Our Ref: 23485_GRSF_Response to DPHI RFI 18 June_itr_Final

RE: Goulburn River Solar Farm - Response to DPHI Request for Further Information (RFI), dated 18 June 2024

Detailed Response to BCD Comments on the Amended BDARs

Figures 1-3: Hollow dwelling fauna and blue wren, observed during thermal drone surveys at Goulburn River Solar Farm.

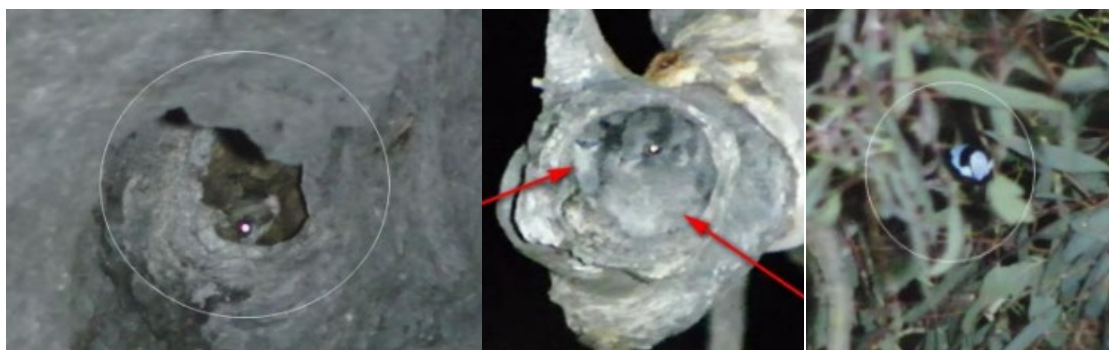
BCS recommended action: Complete additional targeted surveys for squirrel glider (*Petaurus norfolcensis*) using either

An adequate level of both spotlighting and camera trapping was conducted as part of the EIS BDAR. BCD do not have any published survey guidelines for this species. The methods applied during surveys include both spotlighting and camera trapping as described the BDAR and further summarised below:

The thermal drone surveys were a supplementary survey method and successfully identified non-threatened hollow-dwelling fauna (Common Brushtail Possum, Australian Owlet-nightjar; Figures 1 & 2), roosting parrots (Sulphur Crested Cockatoo, Galah, Eastern Rosella) and Superb Fairywren (Figure 3), suggesting that gliding mammals would have had a high likelihood of being observed, if present. Note also that thermal drones have been shown as being more effective at detecting gliding mammals than spotlighting (Vinson et al., 2020). Squirrel Glider was successfully surveyed for on another Lightsource bp solar farm project (in Central Queensland) in April 2024, using a combination of thermal drone and spotlighting to confirm identification.

Example of Variable Condition of BGW DNG

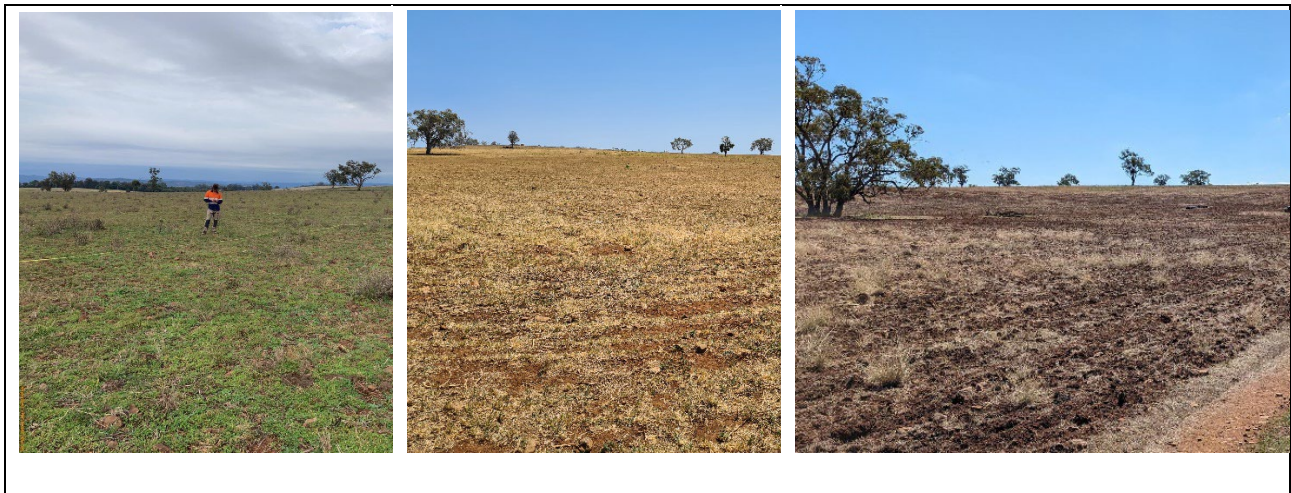
BCS recommended action: Revise the Solar BDAR, in consultation with BCD, to provide additional and appropriate measures for Box Gum Woodland CEEC in accordance with section 7.16(3) of the BC Act.

Low condition PCT 483 DNG at the time of the BAM plots (and VI score assessment), during an extended La Nina weather event with high rainfall and warm weather. This condition state has been used as the basis for assessment under the BAM.

Low condition PCT 483 DNG following a period of low rainfall.

Low condition PCT 483 DNG following seeding by the farmer (as a continuation of standard agricultural land management activities).
